EQUIPMENT/FURNISHINGS - SEAT BELT BRACKET INSPECTION

MODEL	SERIAL NUMBERS
120	8000 thru 15075
140	8000 thru 15075

Cessna Aircraft Company wishes to update the seat belt bracket for airplanes in the field to the latest design.

Figure 1. Seat Belt Bracket Inspection (Sheet 1)

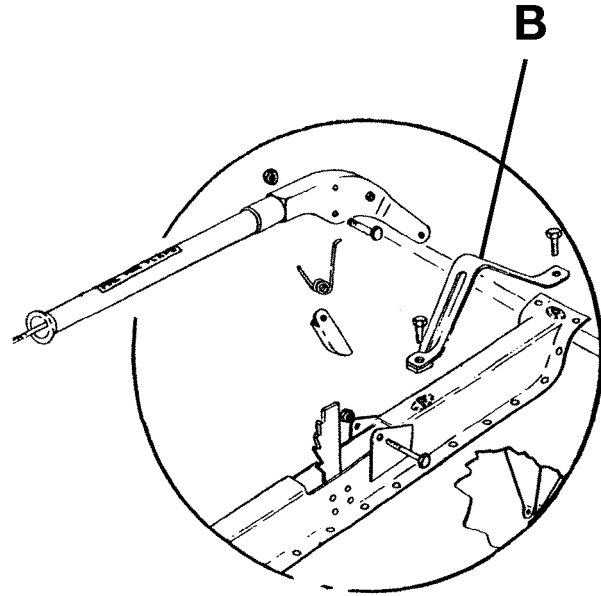
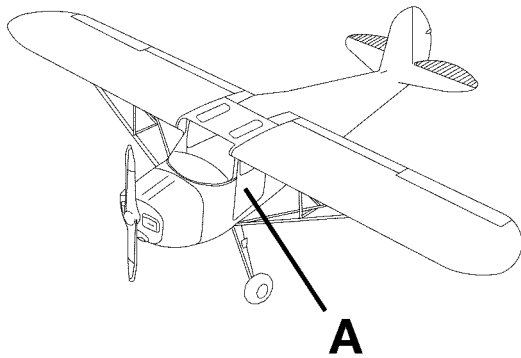
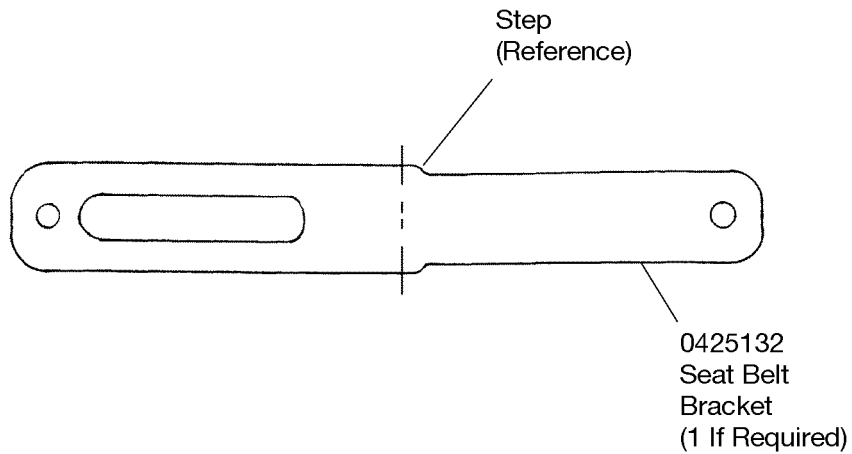
1. (Refer to Figure 1.) Do the visual inspection of the seat belt bracket to make sure that the latest type of seat belt bracket is installed as follows:

- A. If there is a step on the seat belt bracket, go to Step 2.
 - B. If there is no step on the seat belt bracket, do as follows:
 - (1) Prepare the airplane for maintenance.

- (2) Remove the seat belts from the seat belt bracket.
 - (3) Remove and discard the seat belt bracket. Keep the serviceable attachment hardware.
 - (4) Install the new 0425132 Seat Belt Bracket with the kept attachment hardware.
